Docket Item #7
BAR CASE #2006-0128

BAR Meeting
October 4, 2006

ISSUE: Rear addition and alterations

LOCATION: 509 Cameron Street

Figure 1 -
Proposed north
elevation

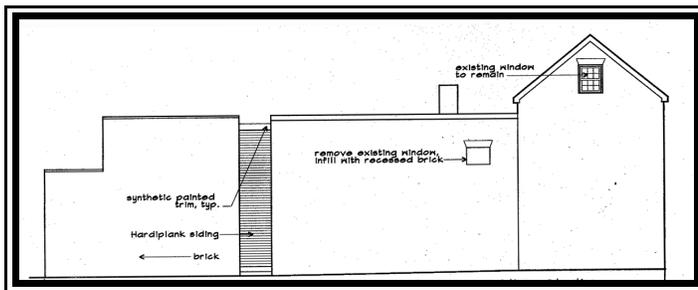
The proposed addition will be at the rear of the existing house and is one and two stories in height and measures approximately 13' in width and 24' length with a two story connector approximately 4' in length between the rear of the existing flounder and the new addition. The two story section will have a brick veneer and the one story section will be sheathed in HardiPlank. A one story section will extend to the east property line enclosing an open space area to the rear of the historic main block. This section will also have brick veneer and an open

deck on the south and north ends. The hyphen will also be clad in HardiPlank. The new addition will have three six-over-nine clad simulated divided light windows on the first level. The single oculus window in the rear wall of the flounder will be relocated to the second level of the north elevation of the new addition. All trimwork is proposed to be of Fypon.

Staff is supportive of the proposal for a number of reasons. First, it responds to suggestions concerning the parti recommended by the Board at the September 6th public hearing. Second, the massing of the rear addition is similar to a number of other additions approved by the Board at the rear of early 19th century houses with existing ells. Third, the rear of the house is only minimally visible across the public surface parking lot from North St. Asaph Street and the public perception of the house from the street remains unchanged. And fourth, the Board approved a rear addition to the early 19th century rear flounder at the residence adjacent to the west at 511 Cameron Street earlier this year (BAR Case #2006-0012, 2/15/06) which clearly changed the historic configuration creating, in the view of staff, the precedent for a similar type addition at this house.
